**Re: Appeal of Planning Commission Approval of AG Forest Wood Processing
Bioenergy Facility Major Use Permit UP 23-05, Initial Study/Mitigated
Negative Declaration IS 23-10**

Dale La Forest & Associates
Environmental Design & Planning
101 E. Alma Street, Suite 100-A
Mt. Shasta, California 96067
dlaforest@gmail.com
Phone: (530) 918-8625

At your request, I have prepared this Report in response to the County of Lake's IS/MND for the Ag Forest Wood Processing Bioenergy Project ("Project"). My qualifications are attached hereto as "Attachment 1". This report shows that the Project's noise impacts are potentially significant under the California Environmental Quality Act, Pub. Res. Code § 21000 *et seq.*, ("CEQA") and will exceed maximum permissible noise standards set by the County of Lake ("County").

FIGURE A **DISTANCES FROM NOISE SENSITIVE RECEPTORS TO WOOD DELIVERIES, UNLOADING, CHIP STORAGE LOADING, AND CHAINSAW NOISE**

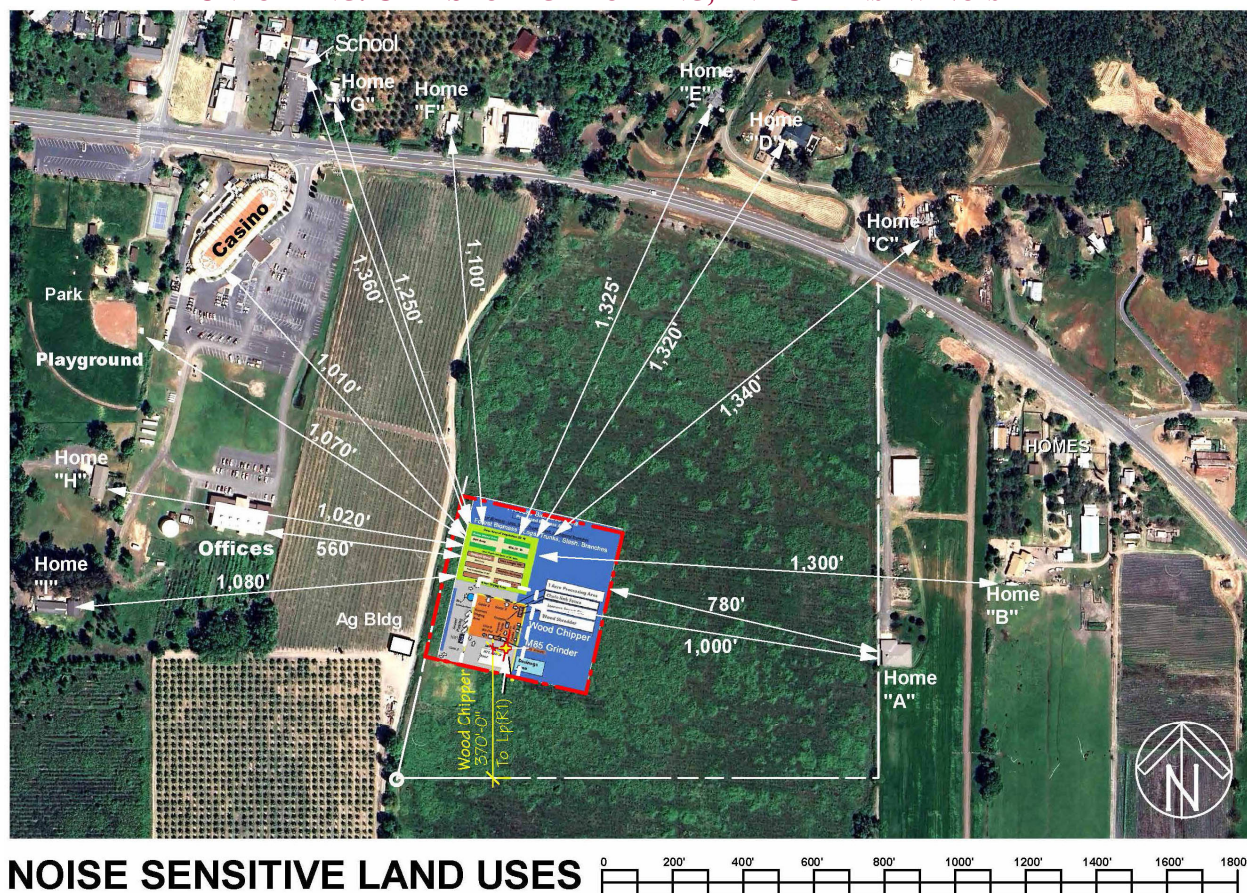
- E. **Operation noise** levels at the Upper Lake Park will exceed the County's noise standards. That Park is located about 1,070 feet northwest of the Project's noise sources. The County's General Plan sets a limit of a *Maximum Allowable Noise Exposure level* of 65 dBA CNEL for "**normally acceptable**" uses at a neighborhood park or playground. This Project's noise from a wood chipper, a tub grinder, a front-end loader, and a chainsaw could generate a noise level of **66.2 dBA CNEL** at the Park when that combined noise is added to the existing noise in the Park. That resulting noise level, deemed by the General Plan to be "**normally unacceptable**," would exceed this General Plan noise standard. Thus the General Plan recommends that at that excessive noise level, the Project's development should generally be discouraged. That law is triggered because the IS/MND does not include a mandatory, detailed noise analysis and because needed insulation features (like a noise wall) are not included to protect the public using this Park. (See p. 30.)

- F. **Operation noise** levels may exceed the County's noise standards at the office building with tribal offices located about 690 feet to the west of major Project noise sources. At that close distance, the noise level from Project operations would cause a significant noise impact. Yet the IS/MND never analyzed that serious risk to those office users that could harm their business work and personal health. (See p. 32 and Figure A.)

- G. **Operation noise** levels at the Running Creek Casino located about 1,010 feet to the northwest of major Project noise sources may also exceed the County's noise standards for commercial uses. (See p. 33 and Figure A.) The Zoning Ordinance allows up to 60 dBA $L_{eq-1\text{ hr}}$, but Project operation noise at the casino could be as high as about 68.2 dBA $L_{eq-1\text{ hr}}$. (See p. 33.)

FIGURE B - DISTANCES FROM NOISE SENSITIVE RECEPTORS TO CONSTRUCTION NOISE

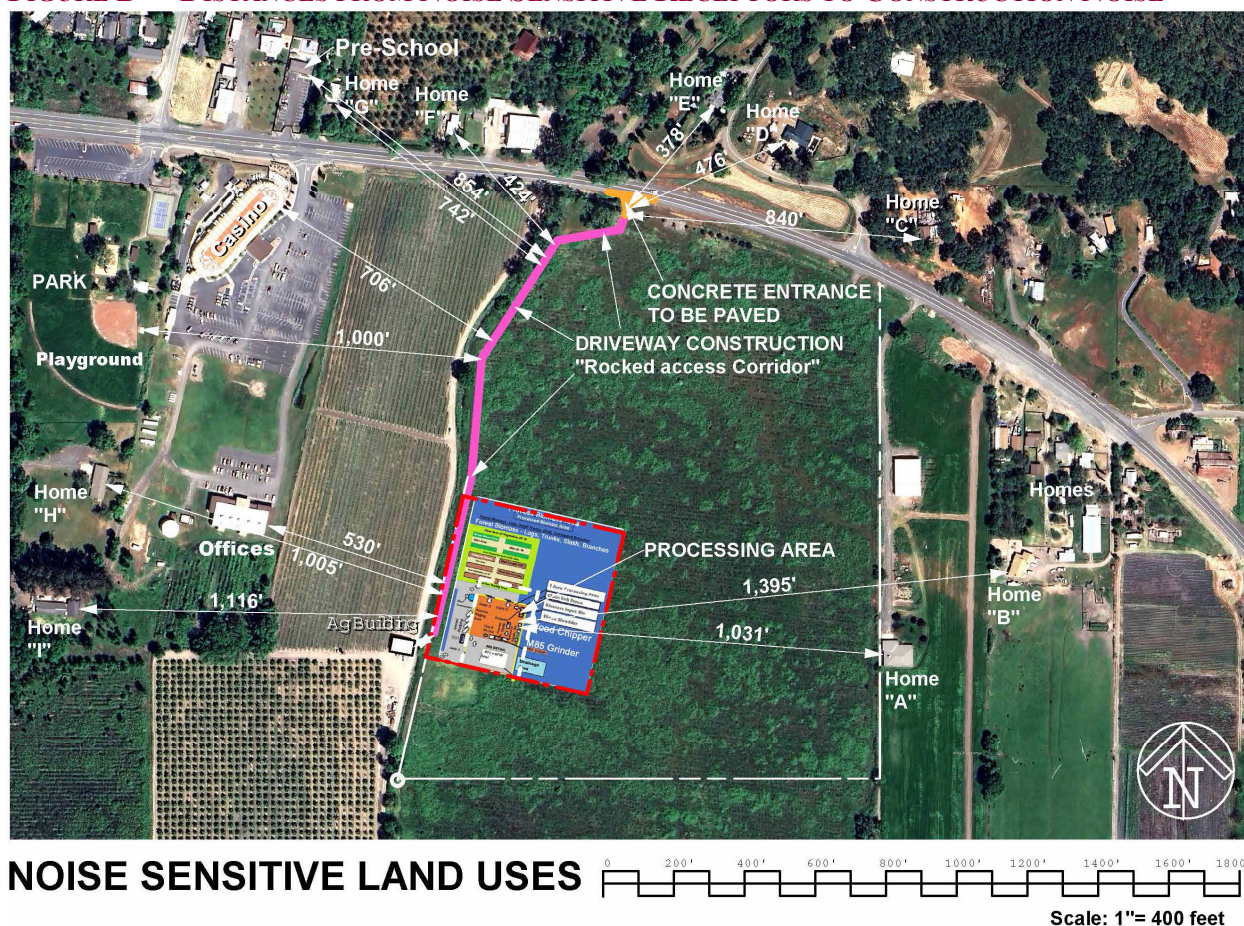
DRIVEWAY CONSTRUCTION COULD GENERATE NOISE LEVELS INSIDE SOME NEIGHBORING HOMES THAT EXCEED THE COUNTY'S GENERAL PLAN 45 dBA CNEL INTERIOR NOISE LIMIT.

With an exterior noise level of 71.6 dBA CNEL at Homes "H" and "I's windows, and with a typical attenuation (reduction) factor of 20 dBA due to noise passing through the walls and roof of a home with its windows closed, the interior noise level indoors would be as much **51.6 dBA CNEL**.¹⁹ That interior noise level due to Project construction would exceed the Building Code standards and the County General Plan's maximum allowable **45 dBA CNEL** interior noise limit. Even with a slight reduction in noise levels due to atmospheric attenuation of about 1 dB at these distances, the interior noise levels would still exceed the County's maximum standards. Therefore this Project's construction noise impacts to the interior noise levels would be significant at some homes.

FIGURE C - DISTANCES FROM NOISE SENSITIVE RECEPTORS TO WOOD CHIPPER NOISE

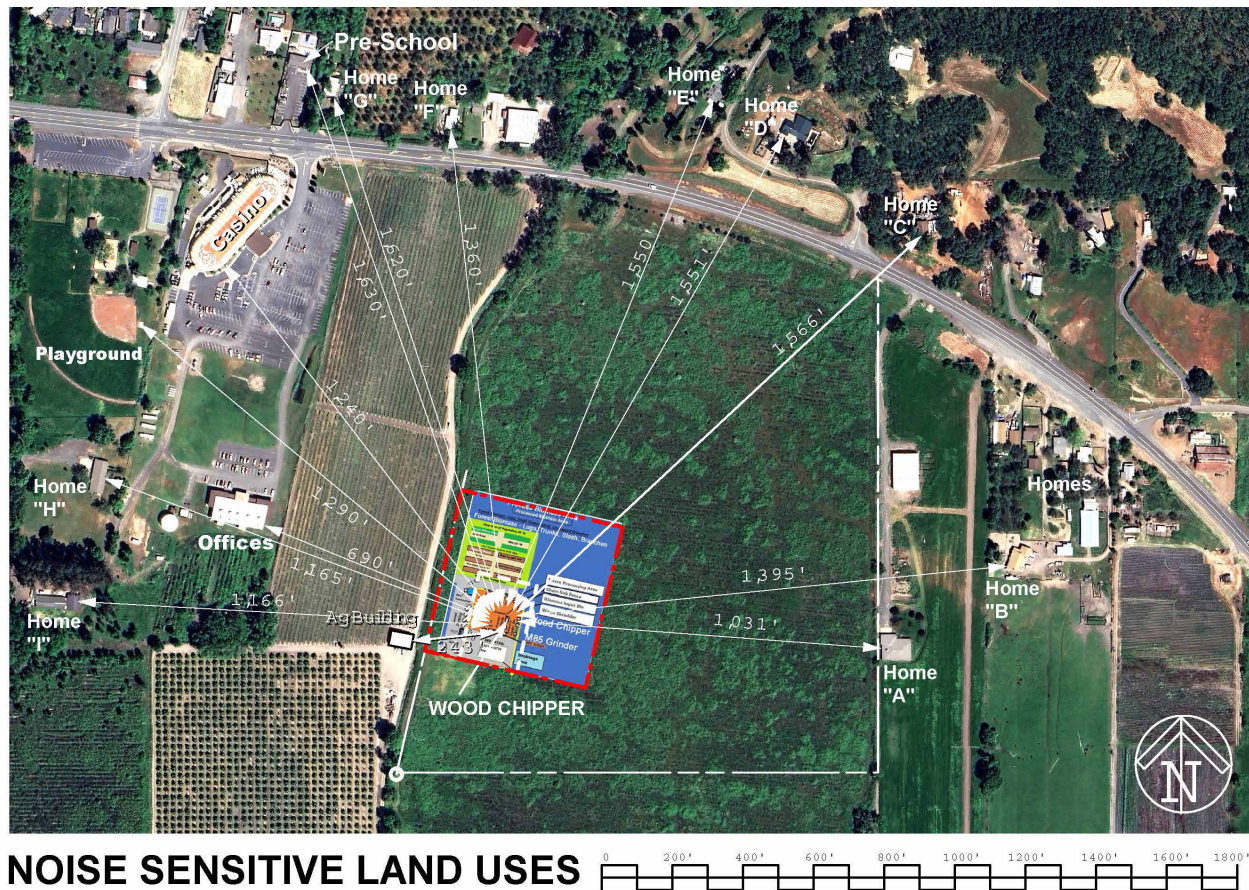
This Project would use a wood chipper to grind up logs and small tree trunks.²⁶ Wood chippers play a crucial role in processing smaller diameter wood, branches, and other woody debris into smaller, more uniform chips. Wood chipper noise levels have been rated by other counties up to 89 dBA L_{max} at 50 feet.²⁷ That accordingly is a noise level also used in this Report. The applicants have not agreed to only use a quieter wood chipper. The Planning Commission enacted no conditions of approval, no mitigation and no other requirement to use a less noisy wood chipper. With few effective noise barriers proposed to remain at all times surrounding the wood chipper, the following calculated noise levels at nearby homes are estimated.

⁴⁹ See Figure C for that distance of 1,290 feet from the Project's central processing area with the chipper to the Park.

FIGURE A - DISTANCES FROM PROJECT OPERATION TO NOISE SENSITIVE RECEPTORS

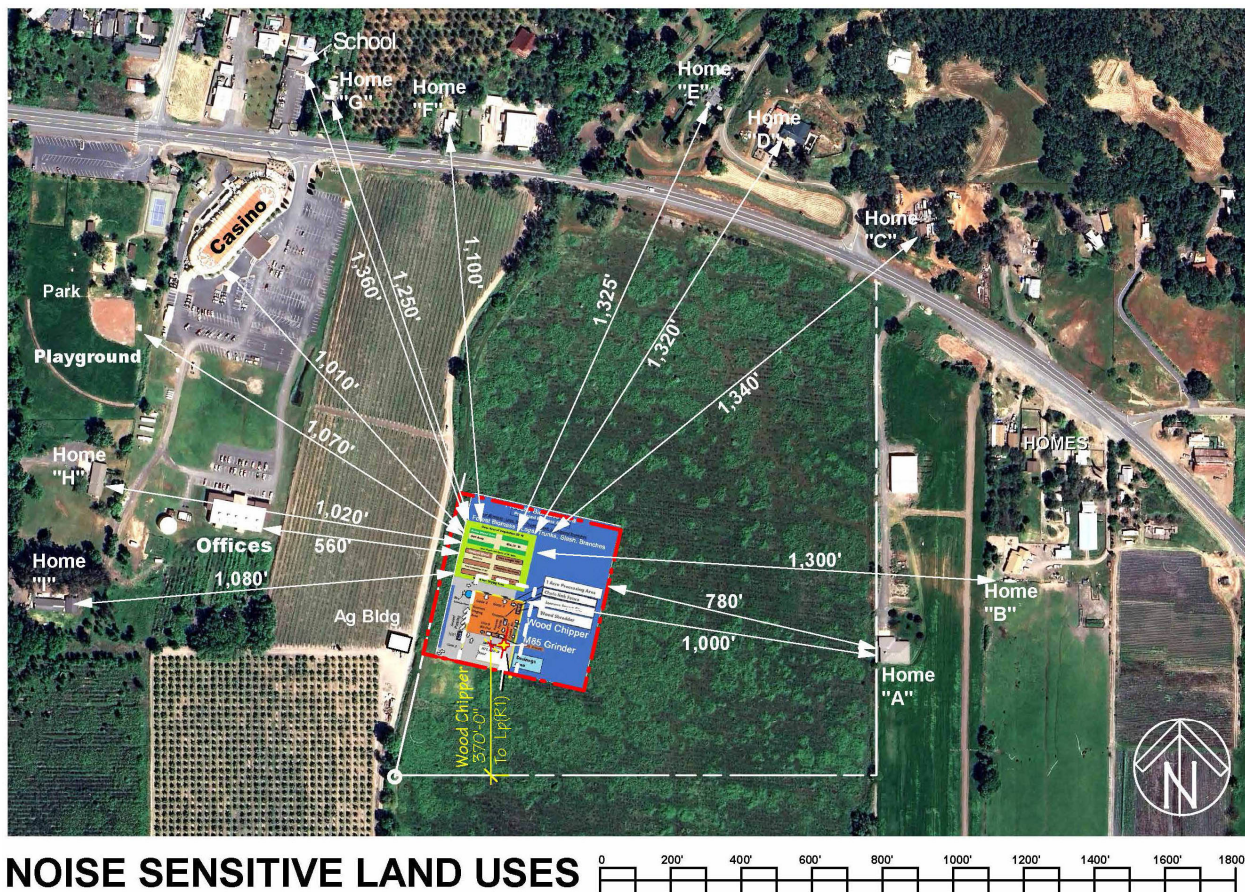
During preparation of this Noise Impacts Report, we were able to uncover the IS/MND's mapping inadequacy by using precise CAD drafting software that County officials and the general public probably do not have access to. But the public should not have such critical mapping information be hidden from them such that they would need specialized software and skills to unravel.

Explanation: Home "F" is about 1,000 to 1,100 feet from where such a chainsaw could be operated at the north end of the Project's 5-acre site. Chainsaw noise levels have been measured at an average of 85 dBA L_{eq} at a 50-foot distance, and up to a maximum of 88 dBA L_{max} at 50 feet.²² If at a distance of 1,050 feet, that 85 dBA L_{eq} average sound level would decrease to 58.6 dBA L_{eq} .²³ Then with atmospheric attenuation absorbing 1.1 dBA over that 1,100-foot distance, the resulting noise level would be **57.5 dBA L_{eq} 1-hr.** That noise level constitutes a significant noise impact at that home because it is greater than the County's maximum 55 dBA L_{eq} 1-hr. noise standard.²⁴

Homes "A", "B", "C", "G", "H", and "I" are less than that 1,325-foot distance from the 5-acre site and, using a similar noise level calculation, they too could also be exposed to excessive noise levels during the operation of a single loud chainsaw. See Figure A above for distances between the 5-acre site where chainsaws could be used and these various homes.
